Safety Recall Notice: Imperial EANx32 Recreational Dive Planner (RDP)

PADI Americas recently discovered an error in some printings of the English language, Imperial EANx32 RDP. No other version of the RDP is affected. Although the risk of injury is exceedingly remote and no injuries have been reported, this table is being recalled.

Table 3 • REPETITIVE DIVE TIMETABLE

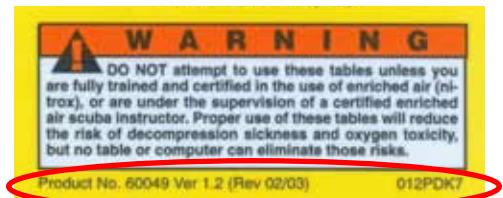
As a double check, on Table 3, check the 110 foot row under Pressure Group G. The table should indicate a Residual Nitrogen Time (upper number in white) of 13 and an Actual Bottom Time (lower number in green) of 12. If this box is blank, you have a misprinted table.

Incorrect Table:

Correct Table: _____
